## ITC PARK STORAGE BUILDING JSP18-07

Consideration at the request of City of Novi for approval of Preliminary Site Plan and Storm Water Management Plan for ITC Park storage building, JSP 18-07. The subject property is located in Section 31 at northeast corner of Eight Mile Road and Napier Road. The applicant is proposing to build a 2,087 square feet single story storage building with 1 restroom for public use. The applicant has indicated that solar panels will be provided on the roof of the building, but no ground-mounted equipment is needed.

# PLAN REVIEW CENTER REPORT

**Review Date:** April 20, 2018  
**Review Type:** Preliminary/Final Site Plan  
**Project Name:** **JSP 18-07 ITC STORAGE BUILDING**  
**Plan Date:** March 29, 2018  
**Prepared by:** Sri Komaragiri, Planner  
**Contact:** **E-mail:** skomaragiri@cityofnovi.org; **Phone:** (248) 735-5607

ORIGINAL ISSUE DATE: MARCH 3, 2018  
 PEA JOB NO. 2017-235  
 SCALE: 1" = 20'  
 DRAWING NUMBER: C-2.1

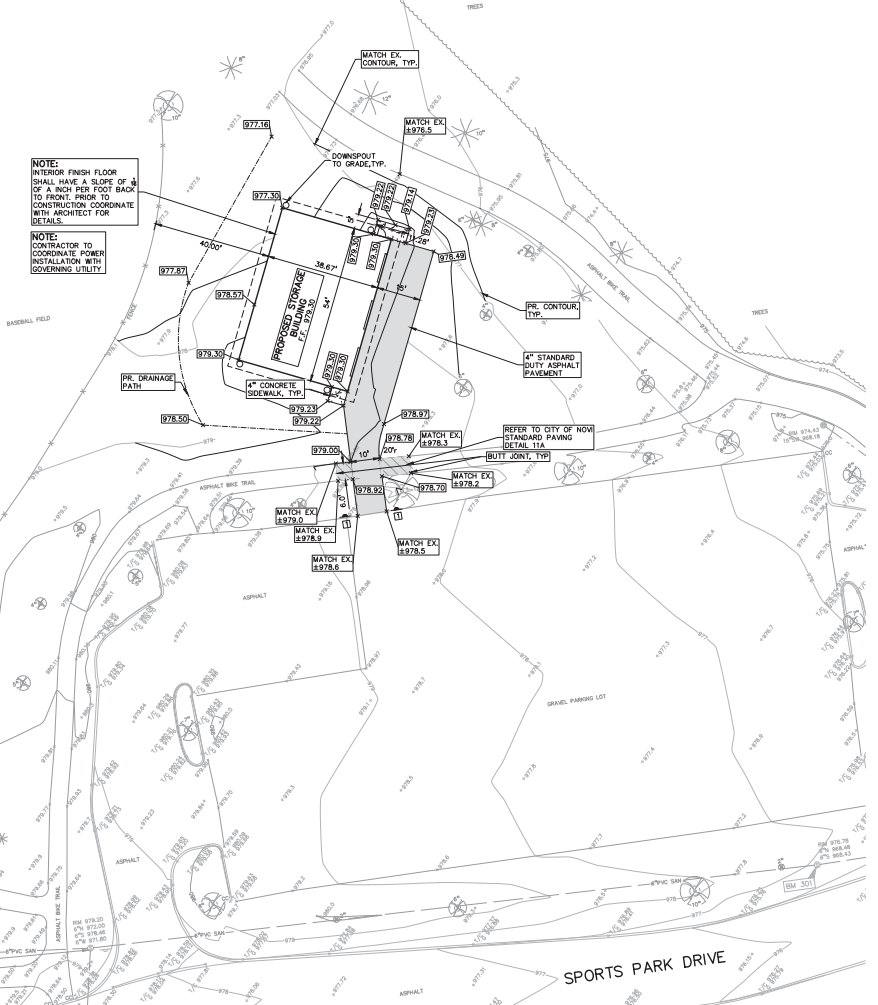
6. Include the newly issued City standard paving details in the plan set. Remove redundant or conflicting details from the site plan sheets. The asphalt pavement and sidewalk details as shown on sheet C2.1 and C2.2 are not consistent with City standards. Sidewalk shall have a 4-inch 21AA compacted limestone aggregate base rather than class II sand base (refer to detail 11B on sheet 2 of standard paving details).
